FIRST REVIEW
WC³ Project #: 217-525-169

Subject: Seth Tan SFD – Plan Review Comments

Project Name: Seth Tan SFD

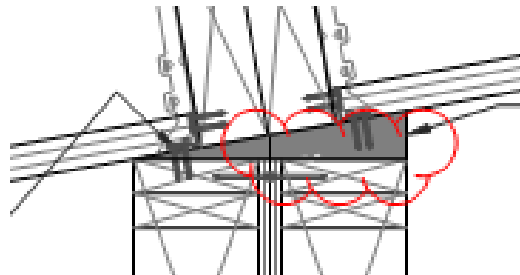
- S1. Details 5-6/SD1: Please clarify the length, spacing, quantity, etc. of the SDS or Lag screws called out as “TBD” in the details.
- S2. Detail 8/SD3: Please clarify the connection of the bevel block shown to the top plate to adequately transfer lateral seismic and wind forces to the top plate, as shown in the image below.
